**RE: 9 Barnard Rd. Section 108.03, Block 3, Lot 54
GENTILE
Continuation Of Planning Board Site Plan Review**

**Re: 9 Barnard Rd. / Section 108.03 – Block 3 – Lot 54
Continuation for Planning Board Site Development Plan Approval**

This letter accompanies a continuation for Planning Board site plan review for proposed legalization of improvements of the property at 9 Barnard Rd. Additional information has been provided as the result of the Planning Board site visit and Consulting Engineer review.

TREE REMOVAL PLAN "Option A"

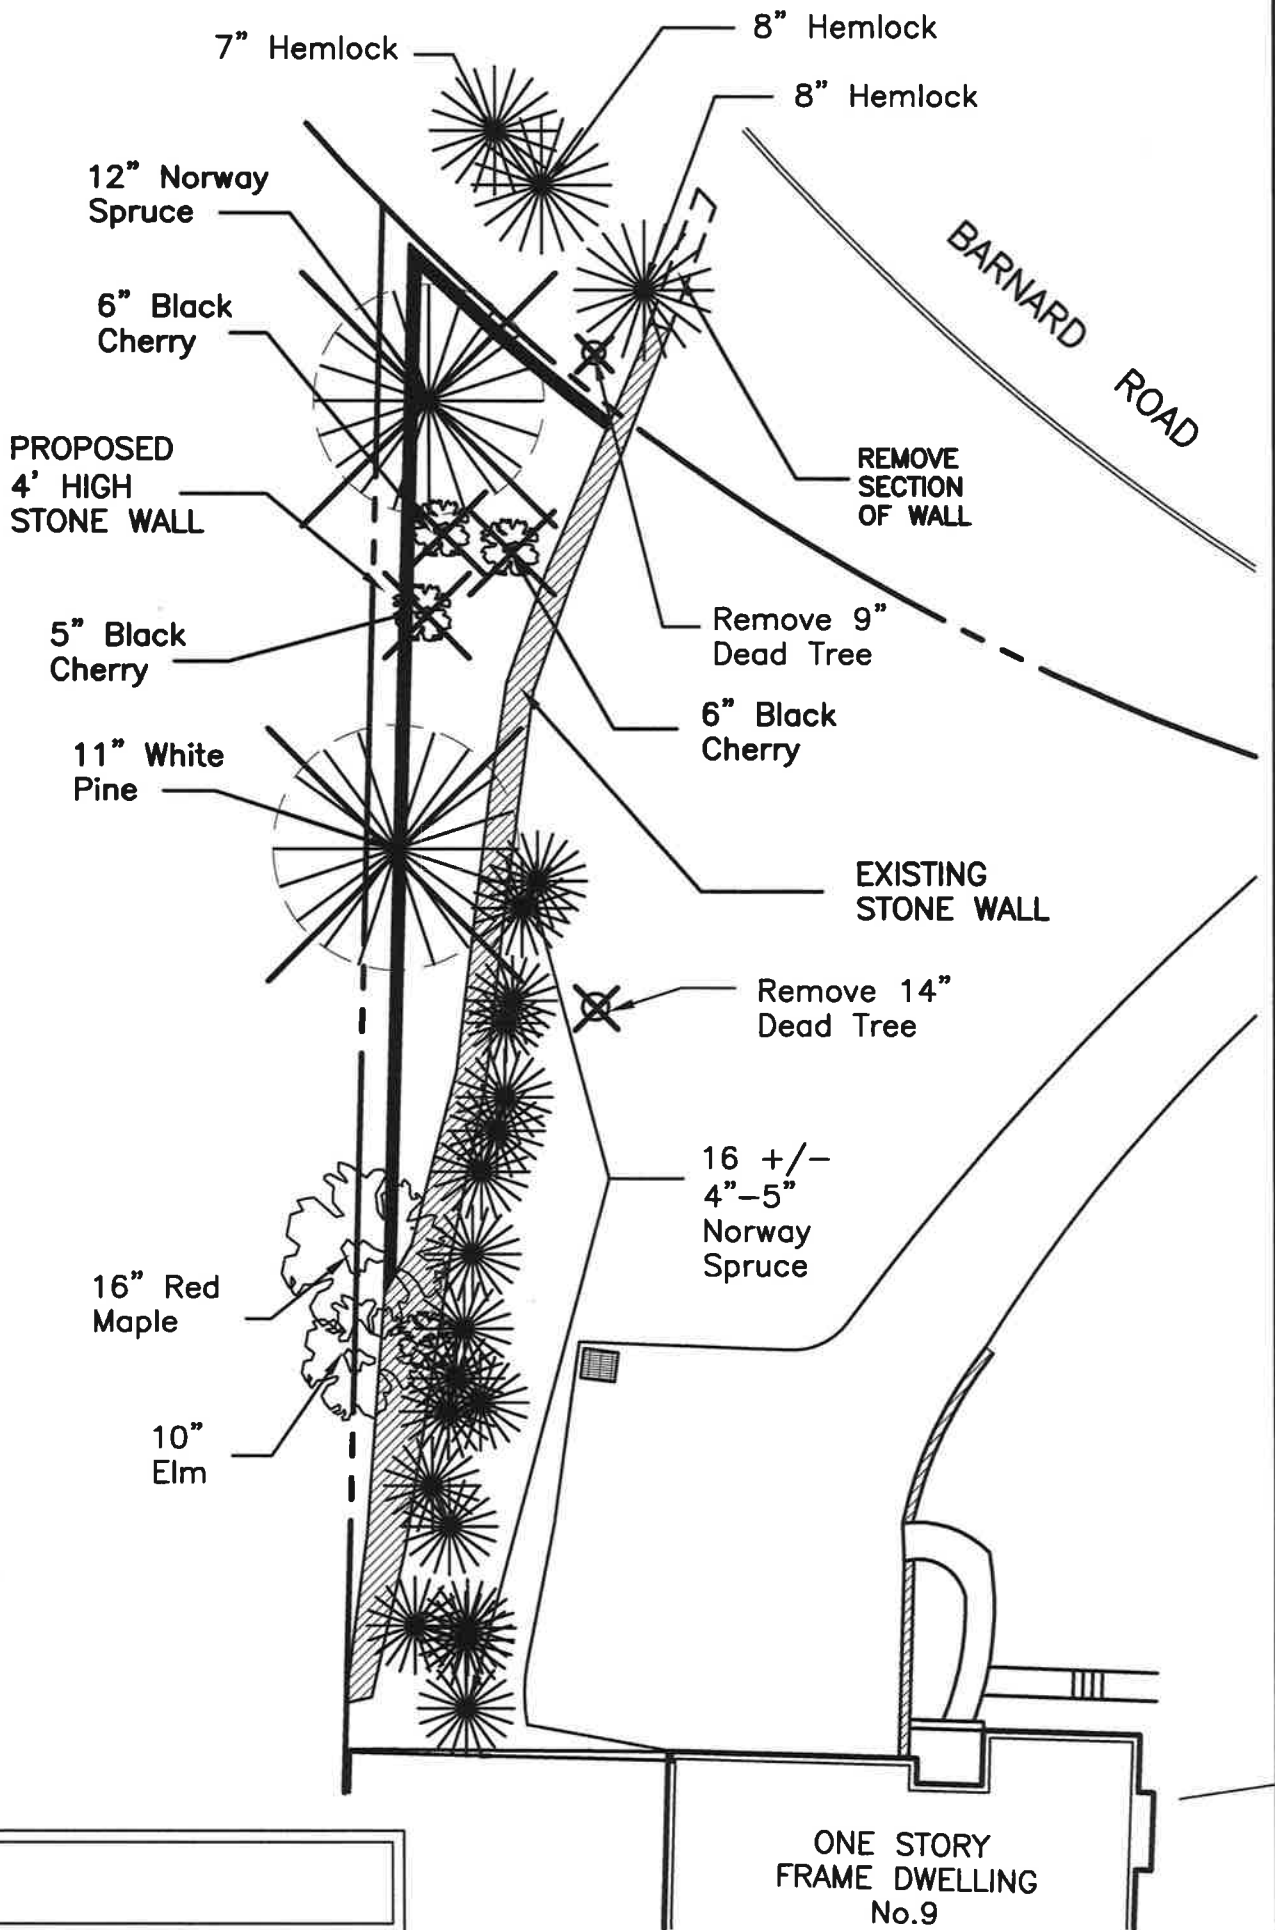
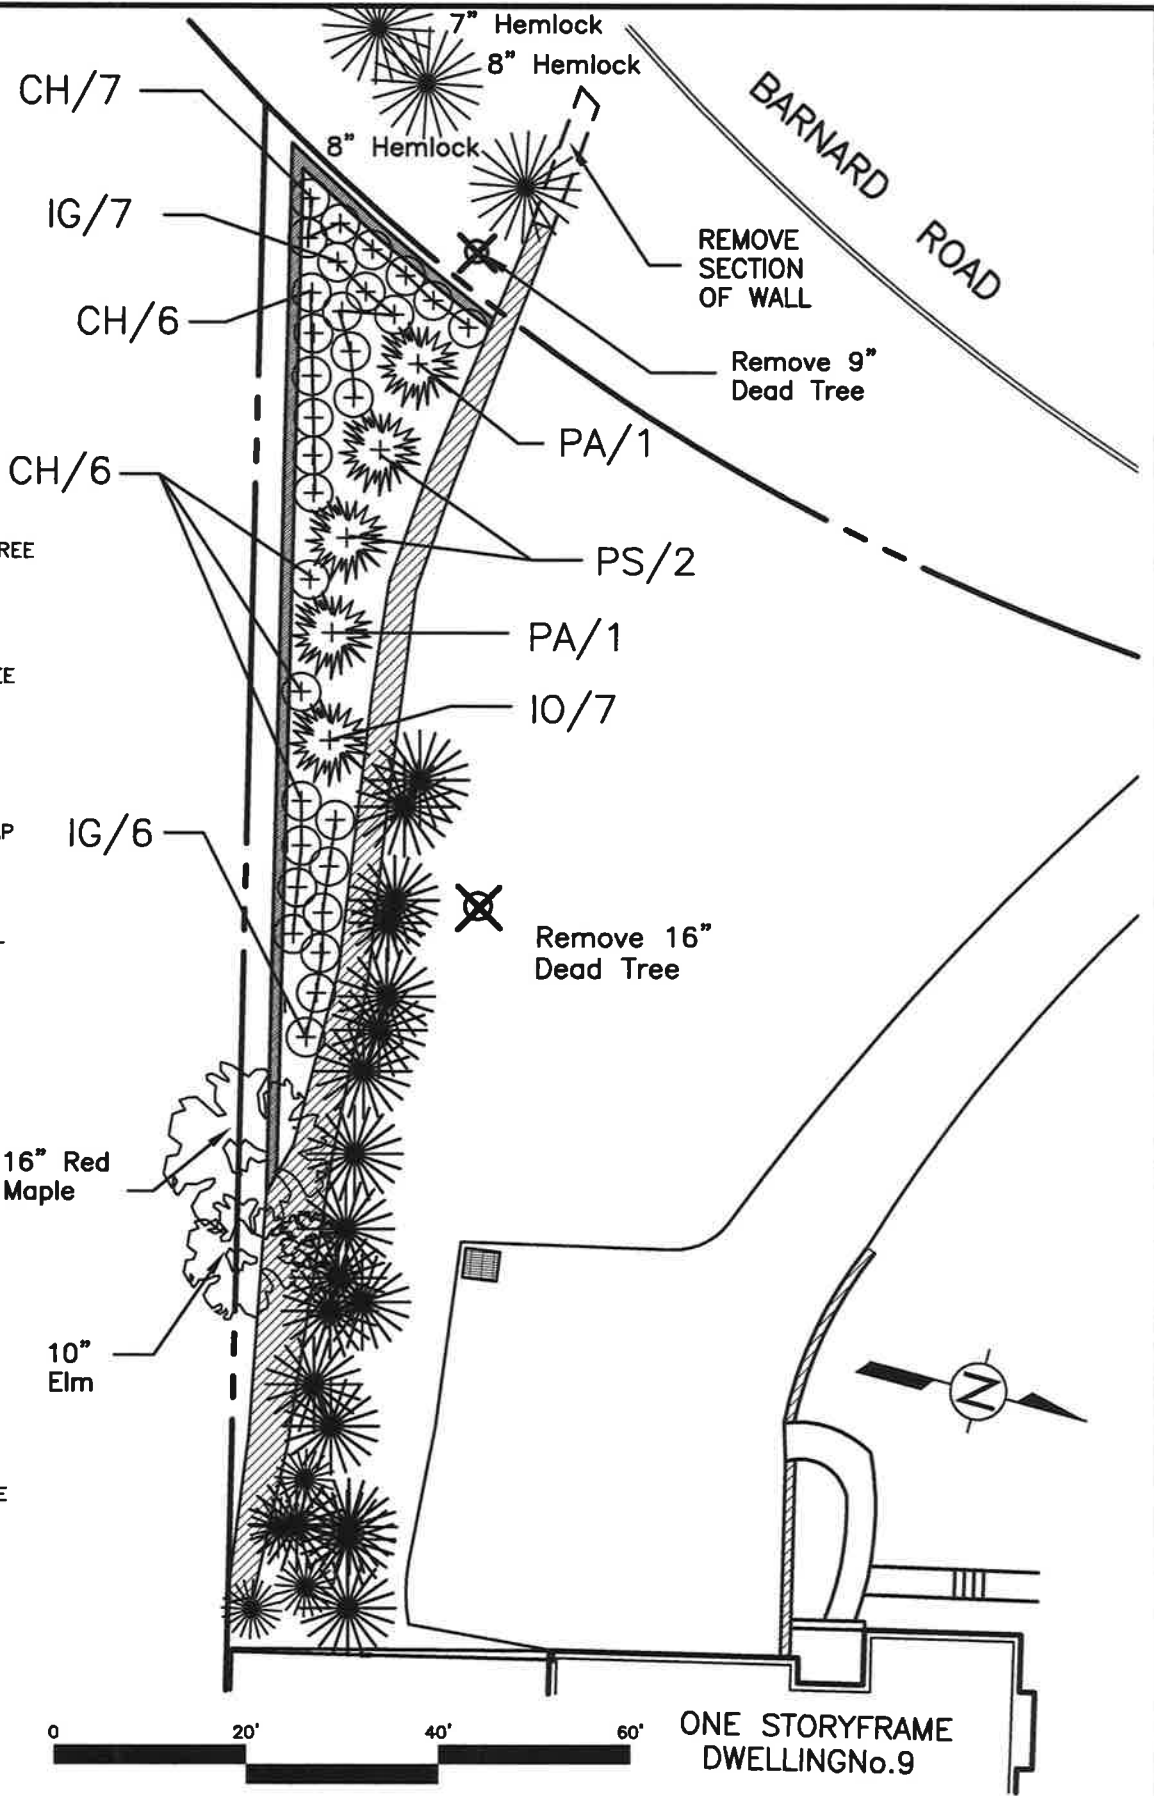
3. The applicant has provided a Landscaping Plan for consideration by the Planning Board. The Site Plan shall depict all Town-regulated trees proposed to be removed or protected within and ten (10) feet beyond the proposed limit of disturbance. It appears that, at a minimum, additional tree removal is required for the proposed lower retaining wall. We note that in addition to the two (2), 20-inch pine trees illustrated on the plan, that there exists a relatively dense vegetated buffer between the adjoining lots. This buffer will require clearing in order to construct the retaining wall. The plan proposes to replant this area with a mix of dwarf junipers and boxwoods. We would recommend that the Planning Board consider requiring a more robust screening plan.

questionable. We note that there is at least one dead tree in the immediate vicinity of the retaining wall (assumed to be the 14" tree illustrated on the plan). This should be confirmed by the applicant. We would recommend that the dead tree be shown to be removed. The Planning Board should discuss whether additional plantings are appropriate.

A landscape plan has been prepared by a landscape architect based upon suggestion by Planning Board. Proposed lower wall no longer being considered.

See Landscape Plan provided.
